PROJECT: INTERMOUNTAIN HEALTHCARE LIVEWELL

DATE OF ADDENDUM: NOVEMBER 27, 2019

ADDENDUM NO: 2

PROJECT # 1918
DATE: 10/09/19
TITLE: DEMOLITION PLAN, MAIN FLOOR PLAN, WALL TYPES

A1 DEMOLITION PLAN
1/8\"/>

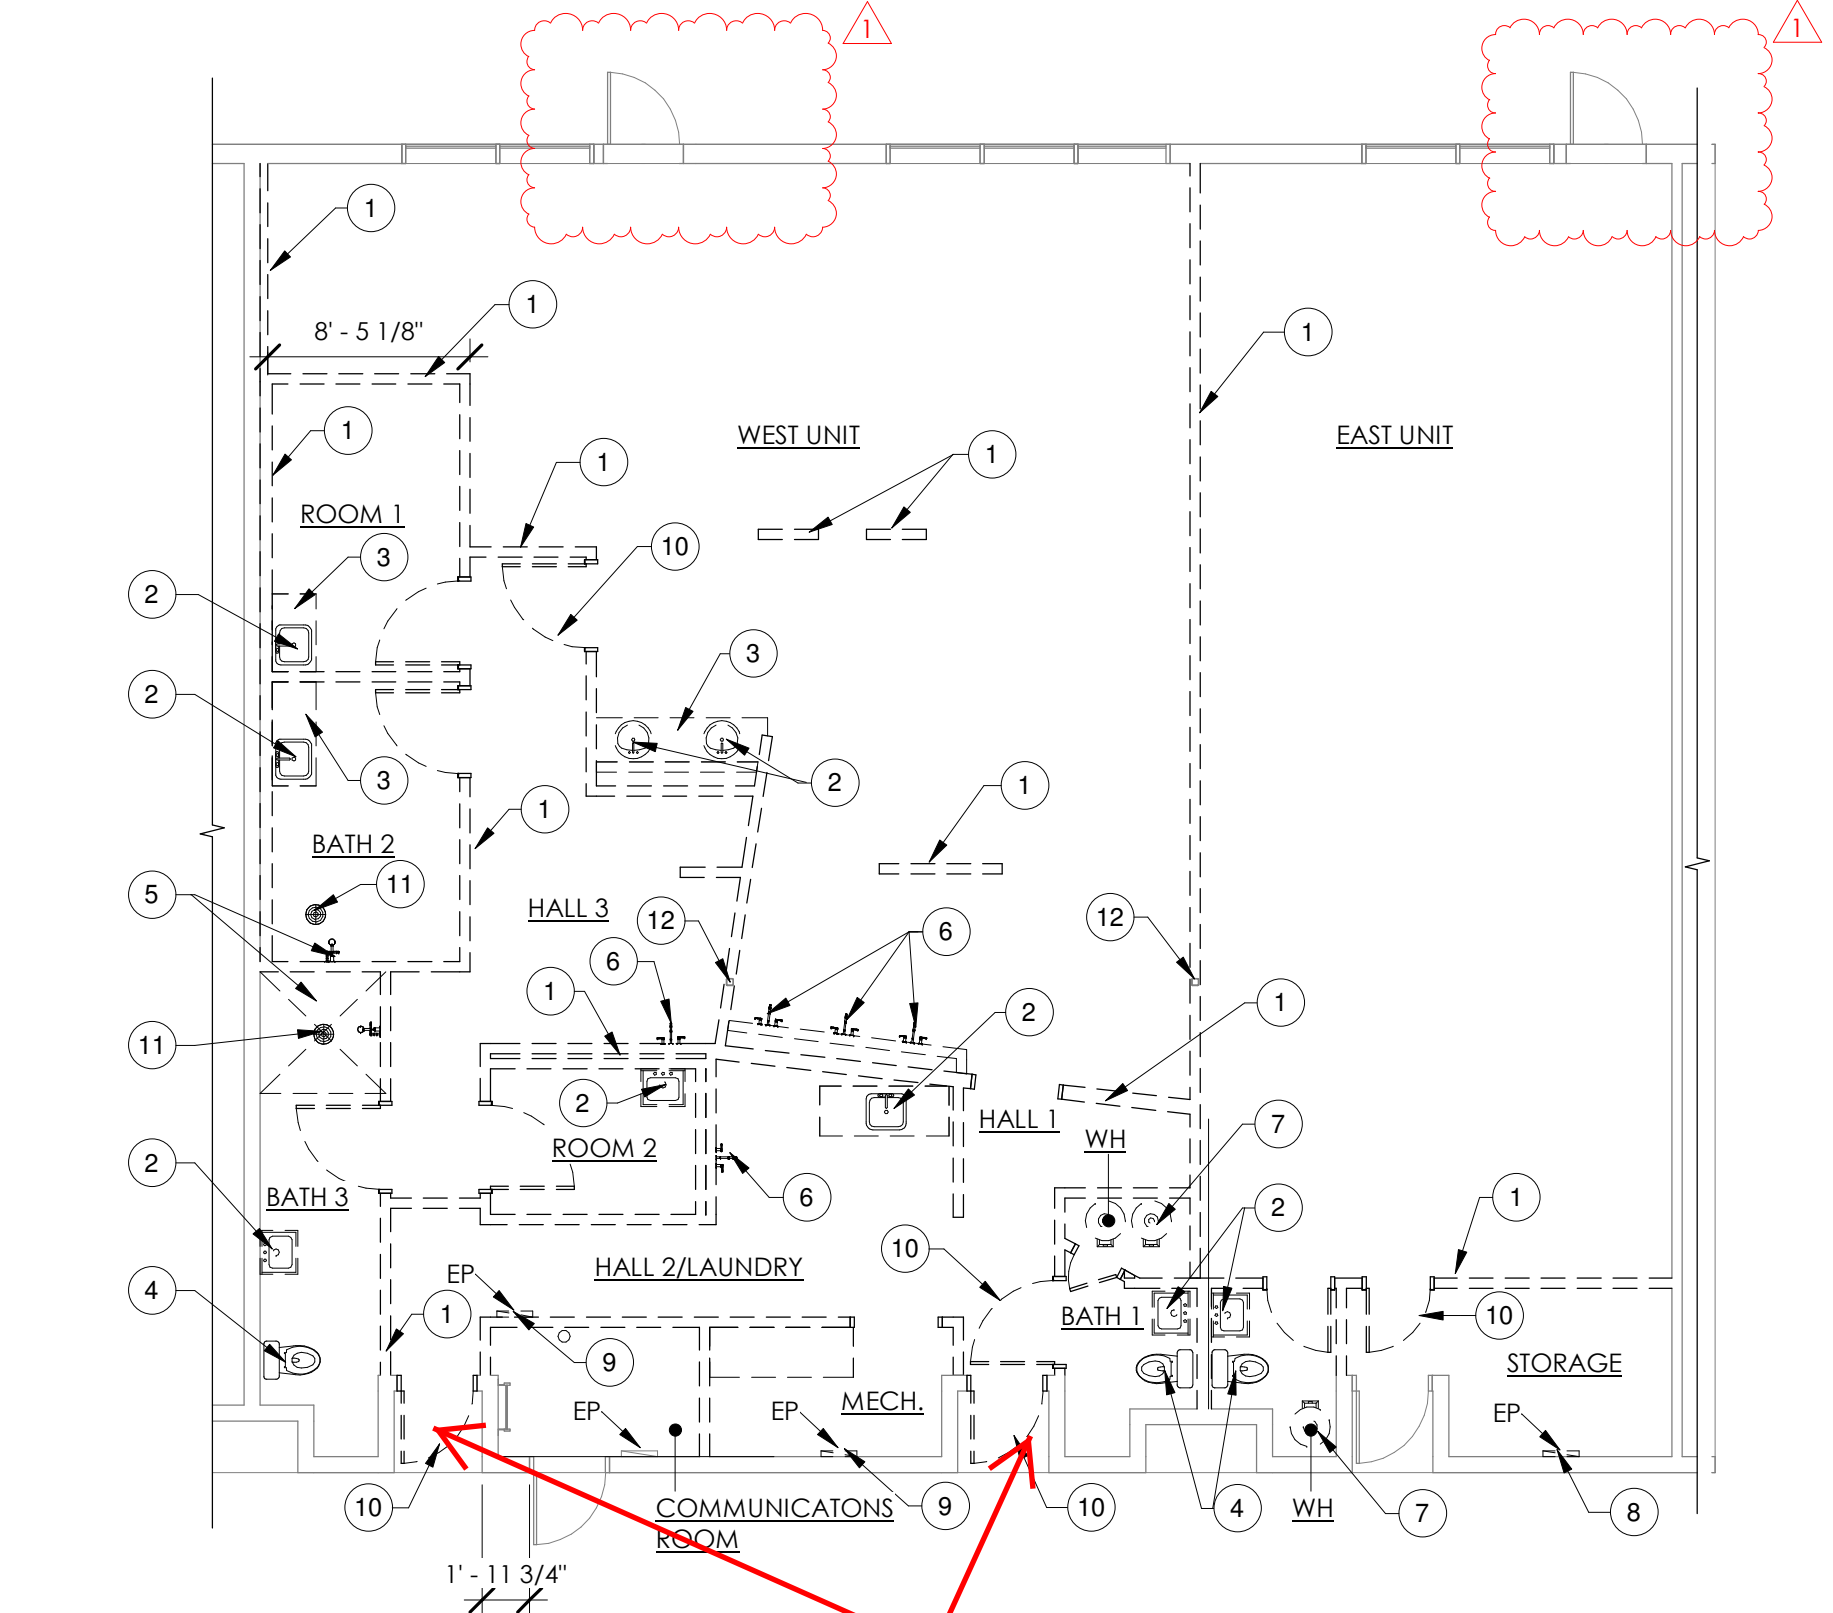
1. A1-Sheet AE-101 shows two existing doors on the south side that are to be removed. These doors are to remain. Contractor is to remove the existing door latch and provide a blank cover for the existing hole. Contractor is to weld the door shut with three lengths of 1/8" x 4" steel plates spaced the same as the door hinges. Paint door and frame to match existing doors on this side of the building. Refer to attachment for door locations.

Doors to be welded shut.
